September 15, 2009

Subject: UniStar Nuclear Energy, NRC Docket No. 52-016  
Response to Request for Additional Information for the  
Calvert Cliffs Nuclear Power Plant, Unit 3  
RAI No. 58, Seismic Design Parameters, Questions 03.07.01-1 and 03.07.01-10  
RAI No. 65, Seismic System Analysis, Questions 03.07.02-18 and 03.07.02-24  
RAI No. 112, Seismic Design Parameters; Question 03.07.01-11

**Response to NRC Request for Additional Information,  
RAI No. 58, Seismic Design Parameters, Questions 03.07.01-1 and 03.07.01-10,  
RAI No. 65, Seismic System Analysis, Questions 03.07.02-18 and 03.07.02-24, and  
RAI No. 112, Seismic Design Parameters; Question 03.07.01-11  
Calvert Cliffs Nuclear Power Plant, Unit 3**

Figure 3.7-1—{CCNPP Unit 3 GMRS and EUR CSDRS (Horizontal) for the Nuclear Island Common Base Mat Structures}

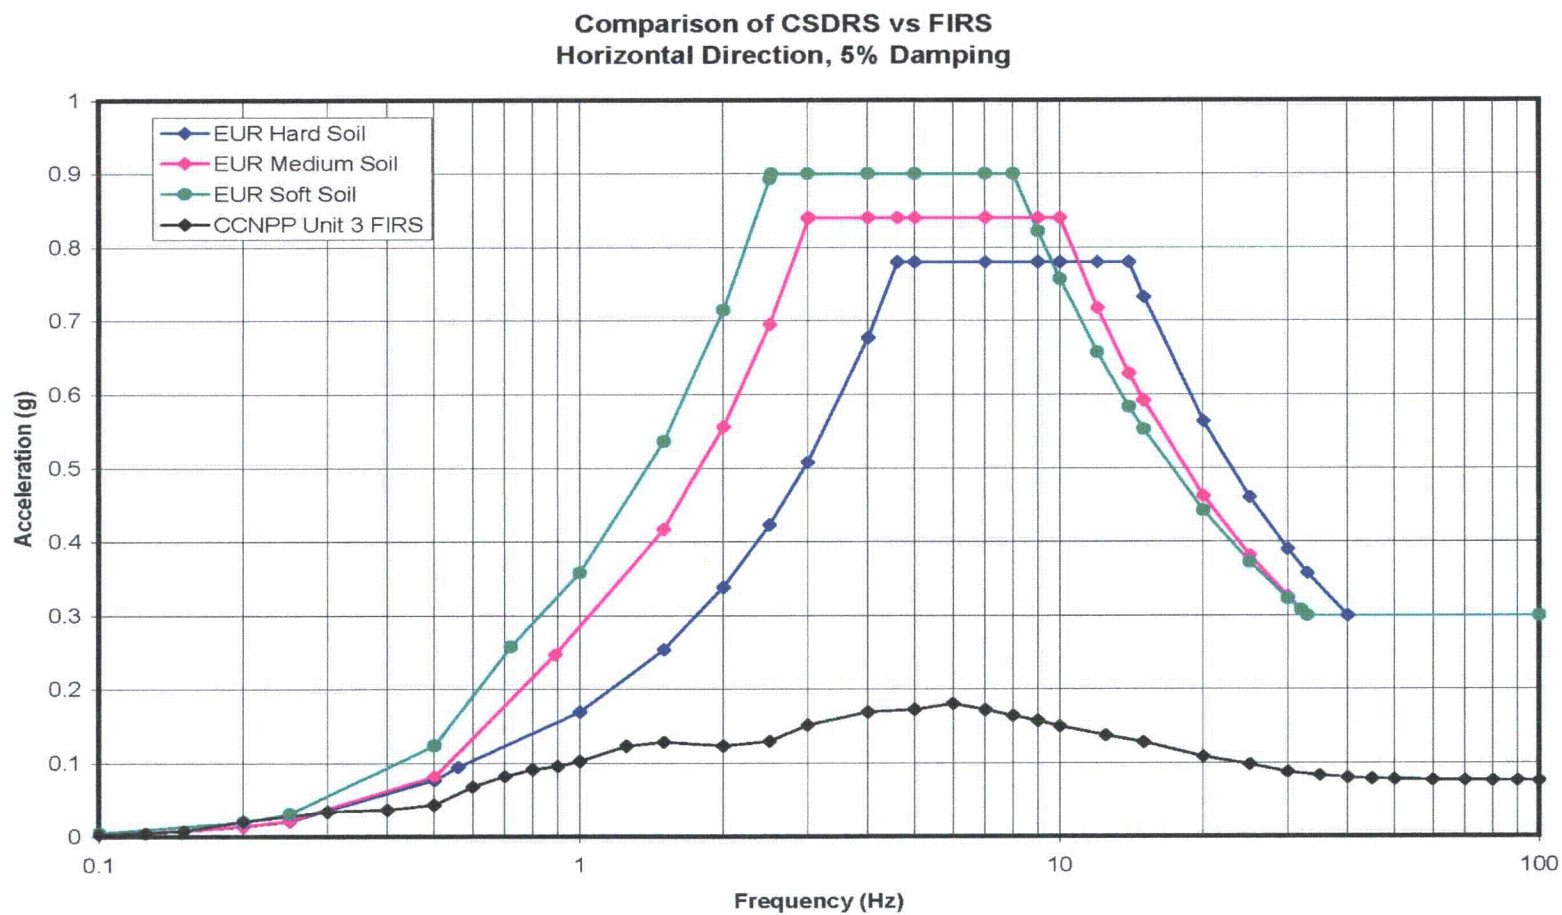
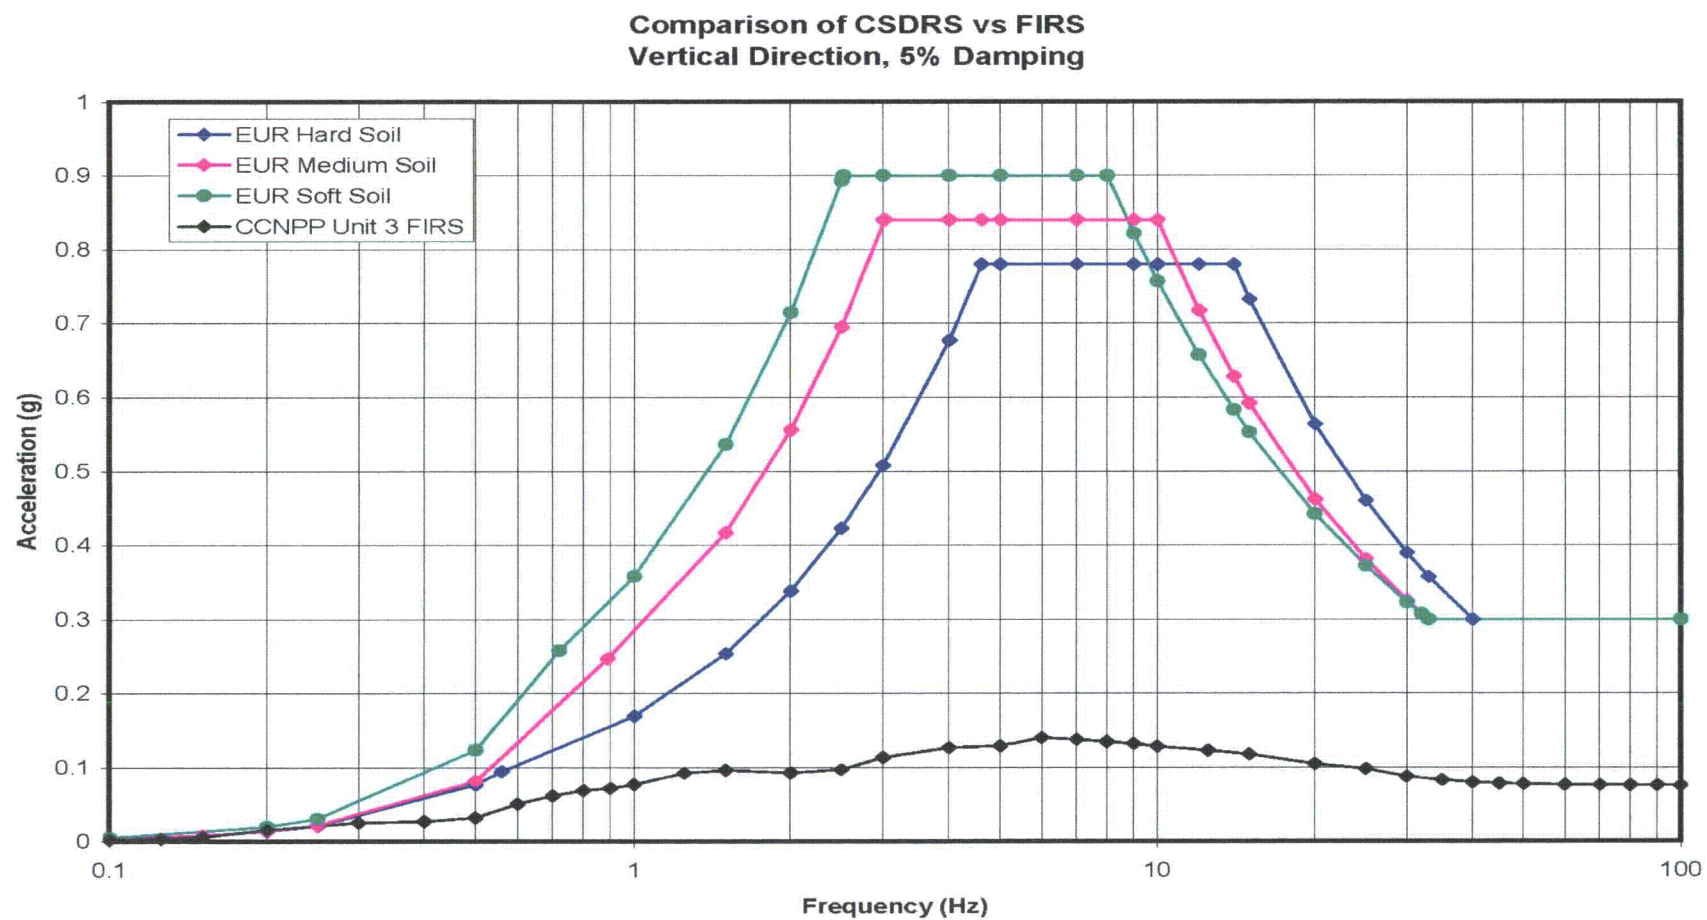
FSAR Section 3.7.1.1.1 (Design Ground Motion Response Spectra), on page 3.0-30, describes the best estimate soil profiles for CCNPP Unit 3. The comparison of the generic site soil columns with the site-specific information shown in FSAR Figure 3.7-7 is based on low-strain best-estimate shear wave velocities. The lower bound shear wave velocities are provided in Table 3.7-2. In this table, layers 4 and 5 have a shear wave velocity of 243.5 m/sec (799 ft/sec), while layers 7 through 25 have a shear wave velocity of 269.4 m/sec (883.9 ft/sec). In both instances, the lower bound shear wave velocity is less than 1000 ft/sec the minimum shear wave velocity for the subgrade to be classified as competent material. In addition, the calculated strain dependent properties under seismic load will lower the shear wave velocities from those shown in Table 3.7-2. SRP 3.7.1, SRP Acceptance Criteria 3, states that if the minimum shear wave velocity is less than 1000 ft/sec, additional studies need to be performed addressing potential impact on soil-structure-interaction (SSI), potential settlements and design of foundation elements. Lower subgrade properties may invalidate the assumption that the mat is rigid in the SSI analysis thus affecting the analysis results, as well as the nuclear island (NI) design loads for seismic and accident design conditions. As the assumption of a non-rigid mat may produce additional seismic bending loads into the mat and NI superstructure, what is the technical justification for using a rigid mat in the SSI analysis with the lower bound soil properties? What is the possible impact on the SSI analysis results and on the design of the foundation mat and supported superstructure?

Soil Structure Interaction (SSI) analyses for the Nuclear Island (NI) common basemat structures are revised using site-specific Safe Shutdown Earthquake (SSE) input motion and corresponding strain-compatible soil properties. FSAR Figure 3.7-1 and Figure 3.7-2 are revised to show a comparison of the Certified Seismic Design Response Spectra (CSDRS) with the horizontal and vertical Foundation Input Response Spectra (FIRS), respectively. FSAR Table 3.7-1, Table 3.7-2, and Table 3.7-3 are revised to show the updated Calvert Cliffs Nuclear Power Plant (CCNPP) Unit 3 best estimate, lower bound, and upper bound soil profiles used for SSI analyses, respectively. Accordingly, FSAR Figure 3.7-6 and Figure 3.7-7 are now based on the shear wave velocities for the site-specific strain-compatible soil profiles, instead of site-specific low-strain shear wave velocities. Based on the updated Figure 3.7-7, the range of shear wave velocities of the CCNPP Unit 3 strain-compatible soil profiles are bounded by the generic strain-compatible soil cases used in the U.S. EPR design certification. However, there are variations in the soil layering from the generic soil profiles considered in design certification. In view of such variations, confirmatory site-specific SSI analyses were performed. The resulting In-Structure Response Spectra (ISRS) at representative locations of the NI common basemat structures are bounded by the corresponding design certification ISRS by a large margin. FSAR Figures 3.7-8 through 3.7-34 will be revised to show the updated ISRS comparisons. The margin available for the site-specific responses is deemed more than adequate to cover any potential increases in loads caused by a non-rigid mat. Since the foundation mat and supported superstructure are designed for design-certification-enveloped loads which bound the site-specific loads by a considerable margin, the impact of any potential increases in the loads due to a non-rigid mat would still be bounded by the design loads.

6. A comparison of the FIRS (or GMRS) for the NI Common basemat structures with the CSDRS is shown in Figure 3.7-1 and Figure 3.7-2 for the horizontal and vertical directions, respectively. This comparison shows that the CSDRS is significantly greater than the FIRS. A comparison of the CCNPP soil profiles with those considered in the ~~certified design~~ U.S. EPR FSAR is shown in Figure 3.7-7. From this comparison, it is less clear that the ~~certified design~~ U.S. EPR FSAR soil profiles ~~is~~ are bounding. Although it is apparent that the CCNPP Unit 3 shear wave velocities are bounded by the ~~certified design~~ U.S. EPR FSAR, the soil layer thicknesses and variations in shear wave velocities are different. Confirmatory site-specific SSI analyses ~~are were~~ performed to demonstrate that the site-specific ~~ground motion SSE~~ coupled with the site-specific soil profiles are bounded by the ~~certified design~~ U.S. EPR FSAR.
